IFB No.        **16-14 Auburn High School ADA Lift**

RE:        **ADDENDUM NO. 1**

Project: **Auburn High School Gym Lift and ADA Toilets**  
Project Numbers: C1741-9

**Project:** **Auburn High School Gym Lift and ADA Toilets**  
**Subject:** Addendum **No. 1**

6 LIFT SECTION

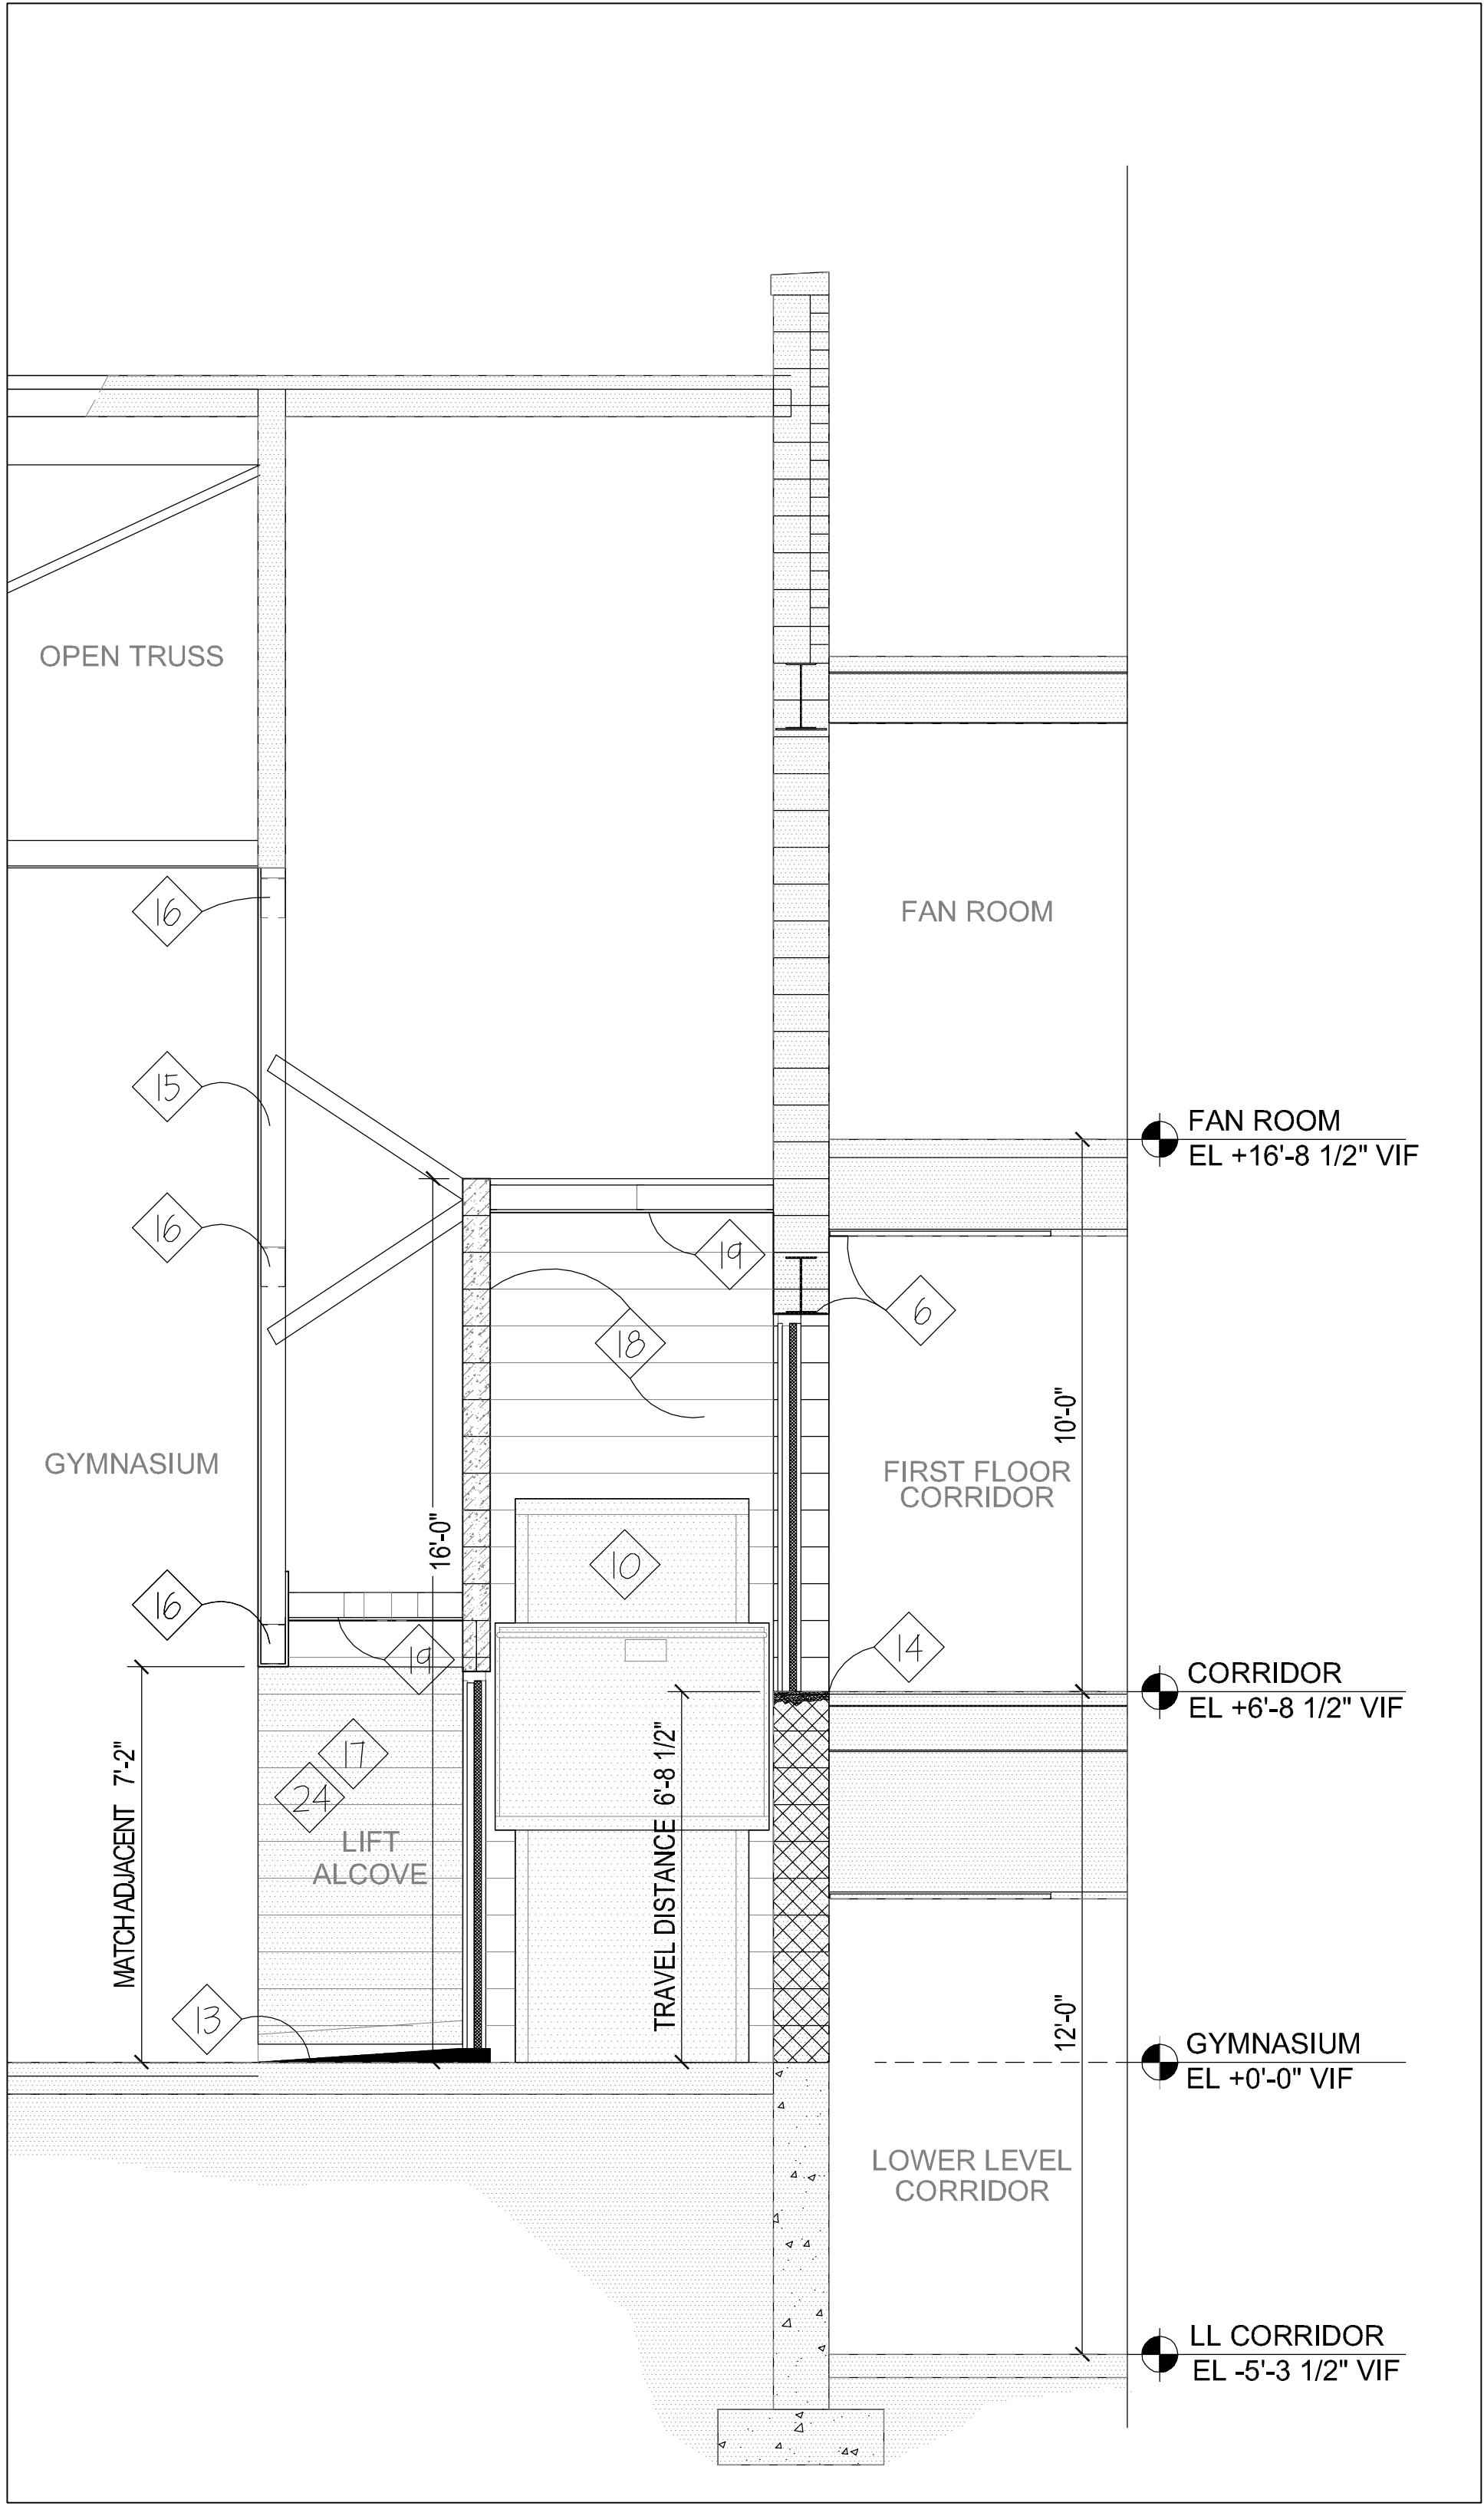
**Sheet A1.0 (Written Change Only)**

- Key Note #9: add to note- "wall tile to extend to face of lift door jamb."
- Key Note #15: replace "cement board" with "two layers of 5/8" Impact-resistant DensArmor Plus GWB or Equal"
- Key Note #17: replace "4" CMU" with "6" MTL Studs @ 16" O.C. W/ two layers of 5/8" Impact-resistant DensArmor Plus GWB or Equal- Paint, 8" above ceiling"
- Key Note #18: replace "6" CMU" (at lift door walls only) with "5" MTL Studs @ 16" O.C. W/ one layer of 5/8" Impact-resistant DensArmor Plus GWB or Equal- Paint"

3. **Q: At the Lift, drawings show CMU for the shaft enclosure. How do we account for the void between the lift doors and the rough opening required by the lift manufacturer?**

A: After discussion about coordination, or installation of the door frame first, then block in-filling around, it was decided to revise ALL the CMU construction at the **ADA Lift** to be metal stud with GWB/Impact resistant GWB. Revision will be given in ADDENDUM #1.

### 2 NEW ADA TOILET PLAN

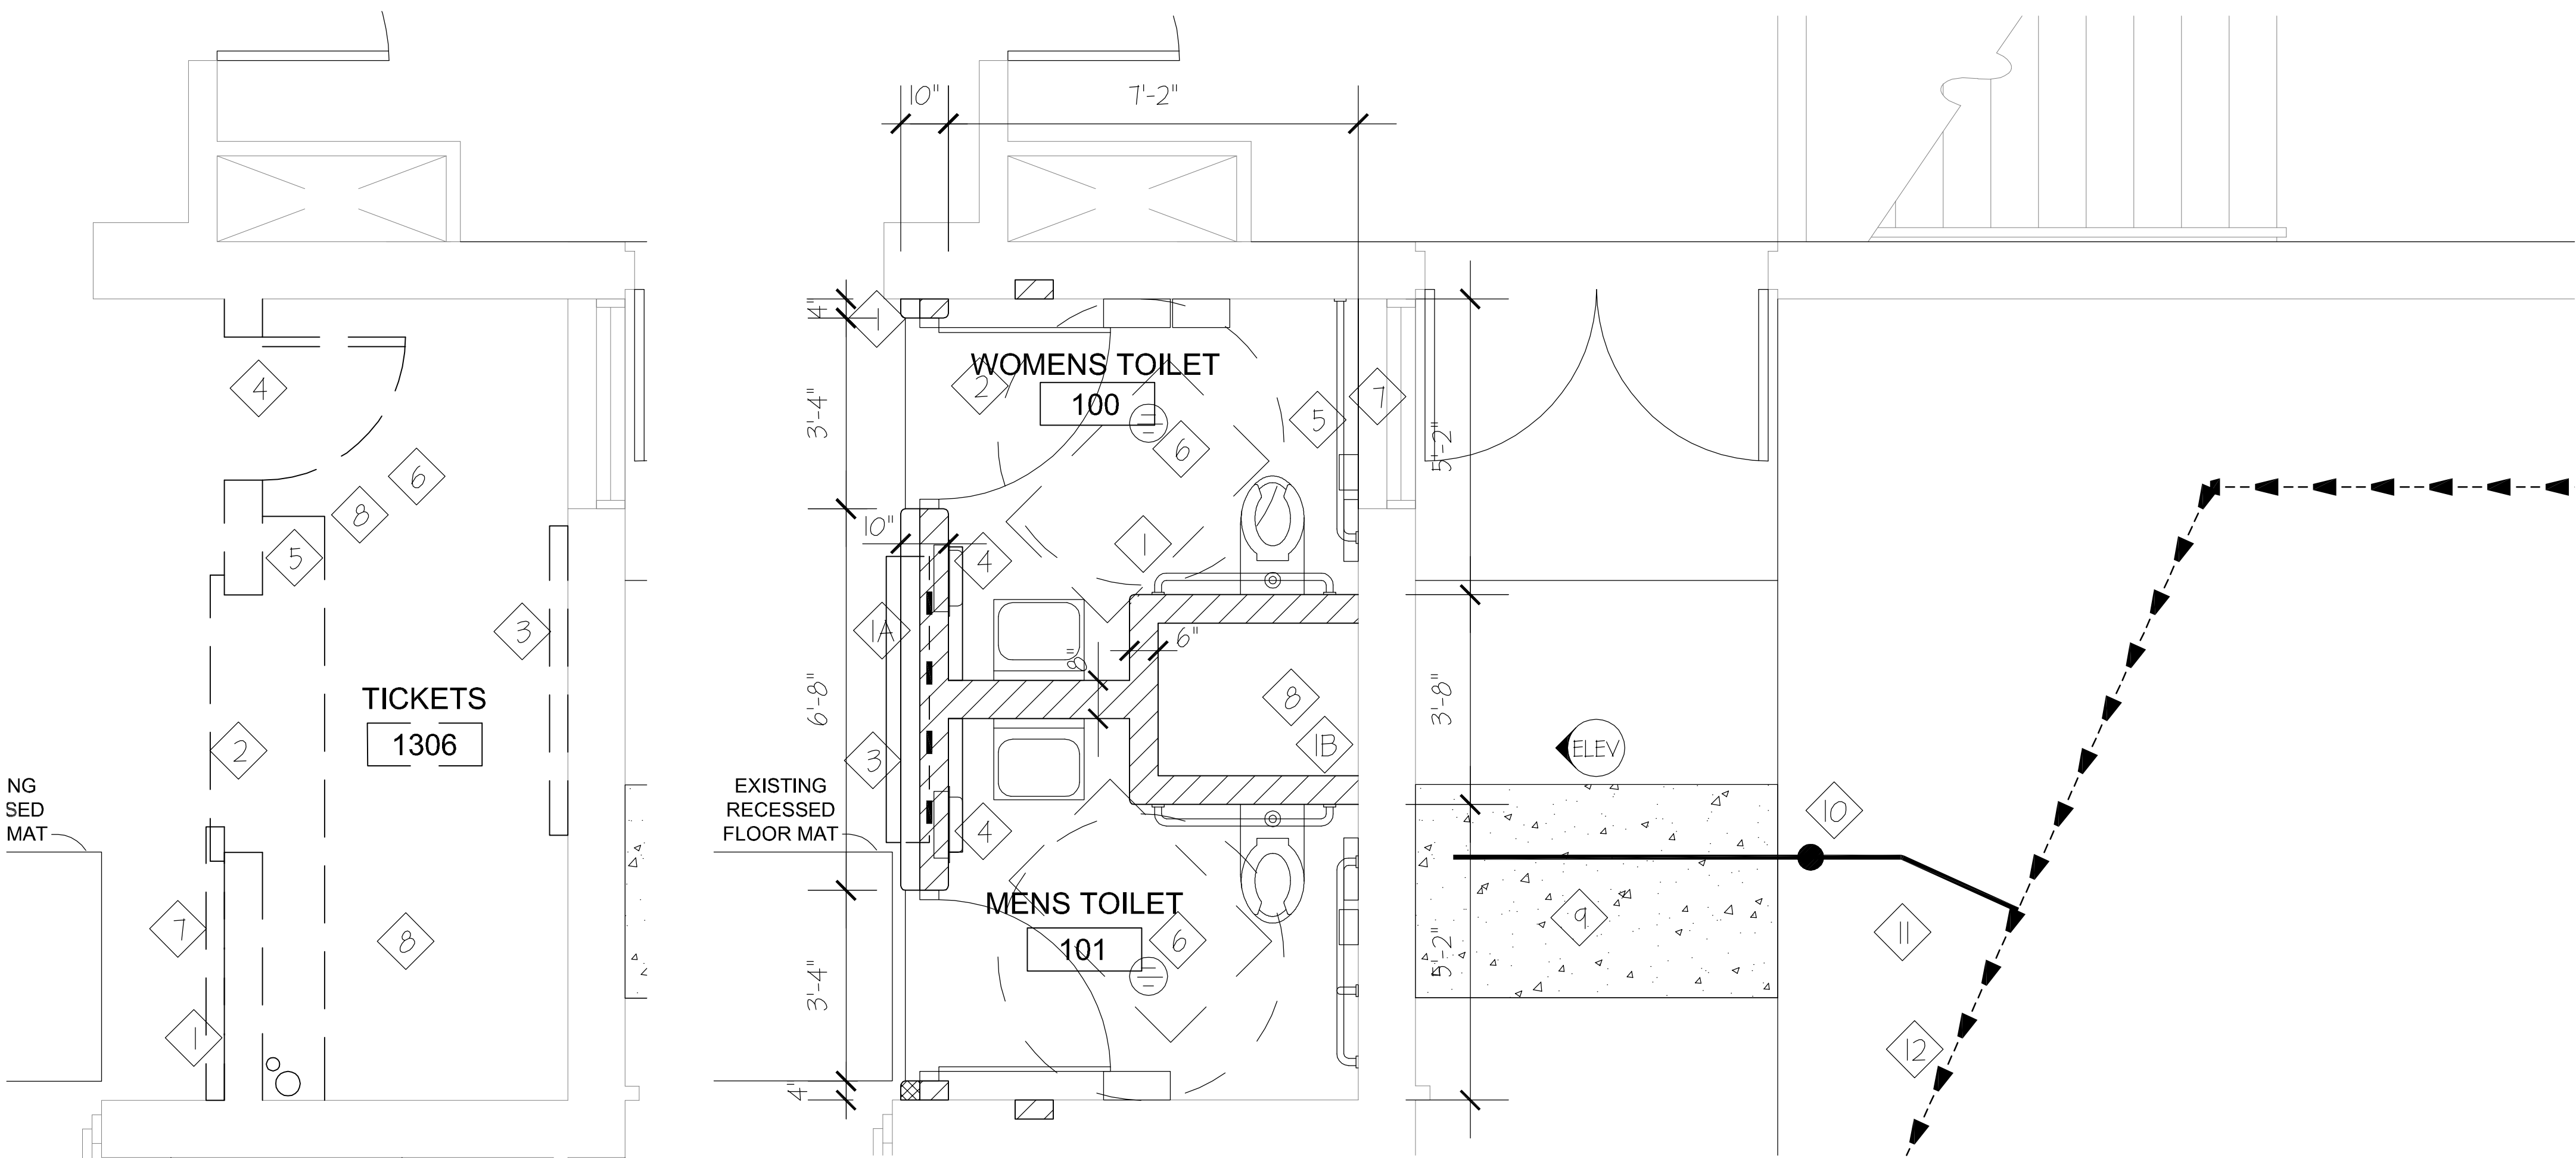
**Sheet A1.1** (*Written Change Only*)

- At Heading "2 NEW ADA TOILET PLAN", ADD note #13 "Plumbing vent thru floor and roof above. Include 4" CMU enclosure to 6" above ceiling (at GYM balcony/classroom level) See note #21 sheet P1.1.0"
- At Heading "6 NEW ADA TOILET- REFLECTED CEILING PLAN", ceiling patch (if required) is graphically shown as ACT/Grid. The ceiling in the stairs is "plaster", not grid.
